SPECIAL PLACEMENT PLAN FOR THORIUM WASTE

Addendum 1 - OSDF Impacted Material Placement Plan
Rev. 0, Date: January 20, 1999

Specialized Placement Plan for Bagged Impacted Material.

FIGURE 1 - TYPICAL SECTION
 BAGGED IMPACTED MATERIAL PLACEMENT

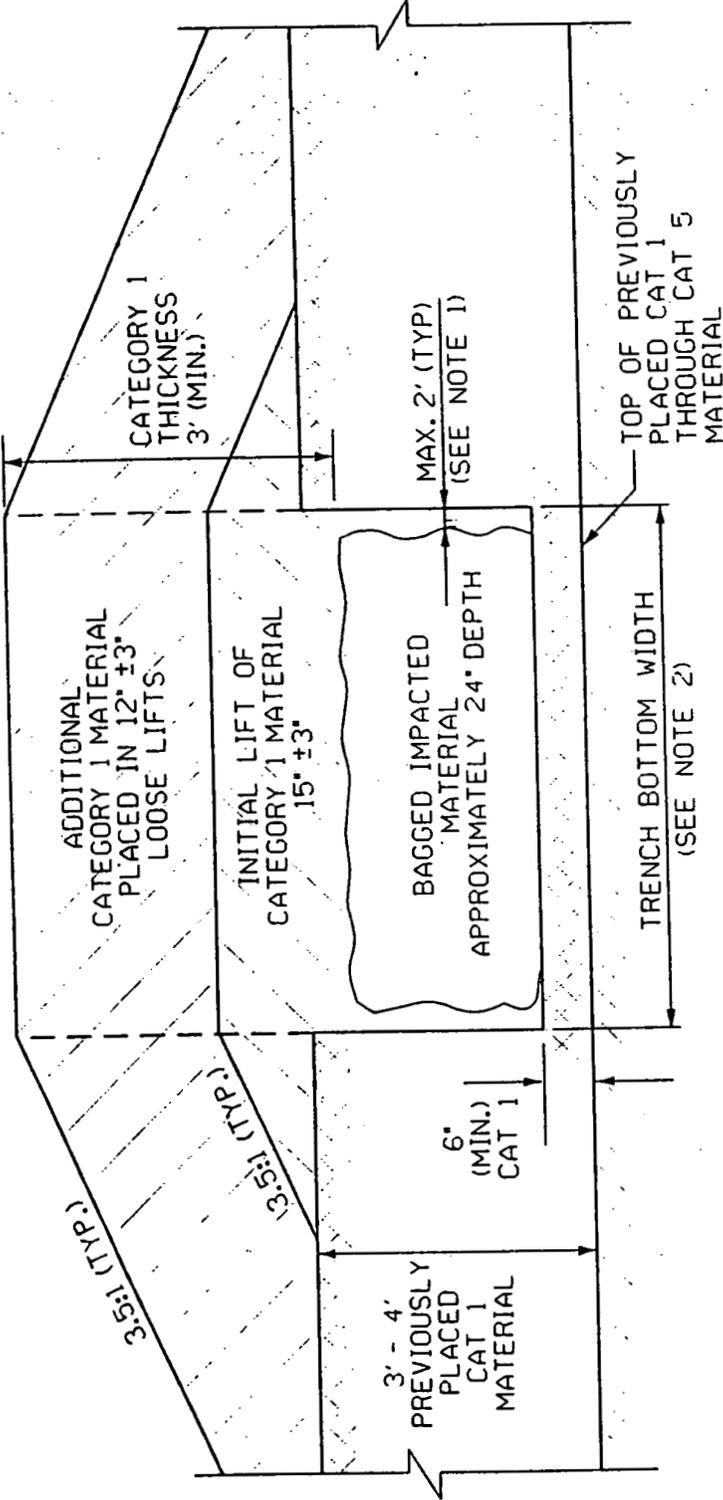
A trench for bagged material placement in the approved grid(s) location shall be excavated, as shown in attached Figure 1. The bottom of the trench shall have minimum of 6 in (150mm) of Category 1 material above a previously placed Category 1 through 5 material. The trench shall not be excavated in previously placed protective, contouring, or select impacted material layers. The width of the trench shall be approximately the width of the

transporting container for the bagged impacted material plus 2 ft (0.6m). The width of the trench is anticipated to be approximately 8 ft (2.4m) to 12 ft (3.6m). Category 1 impacted material excavated from the trench shall be stored at least 6 ft (1.8m) away from the trench opening. The length of the trench shall vary depending on the quantity of bagged impacted material to be placed in the OSDF. The depth of bagged impacted material in the trench shall be approximately 24 in (600mm). The maximum distance between the bag(s) placed in the trench and trench walls and between the bags shall be 2 ft (0.6m). The placement of bagged impacted material shall be performed in accordance with Fernald Environmental Management Project (FEMP) radiological safety procedures, as well as the contractor's Safe Work Plan, to minimize worker exposure.

Compaction shall not be performed directly on the bagged impacted material. Contact with the bagged material shall be minimized by personnel and equipment. After placement of the bagged impacted material in the trench, void spaces between the bags and between the bags and trench walls shall be filled with Category 1 material. The Category 1 material filled in void spaces shall not be compacted. An initial lift of 15 in (376mm) \pm 3 in (76mm) thick Category 1 material shall be placed over the bagged impacted material. The top of the initial lift shall be compacted with a minimum of four passes of a portable flat-plate, self-propelled double drum roller compactor, or a smooth drum vibratory roller and shall not require compaction testing. Additional 12 in (300mm) \pm 3 in (76mm) thick Category 1 lifts shall be placed above the initial lift. Total thickness of Category 1 material placed above the bagged impacted material, including the initial lift, shall be a minimum 3 ft (0.9m) as shown on attached Figure 1. The Category 1 lifts above the initial lift shall be compacted by a CAT 826 compactor, CAT 815 compactor, or equivalent, to meet at least 90 percent of the standard Proctor dry density. The compaction shall be tested in accordance with the IMP Plan.
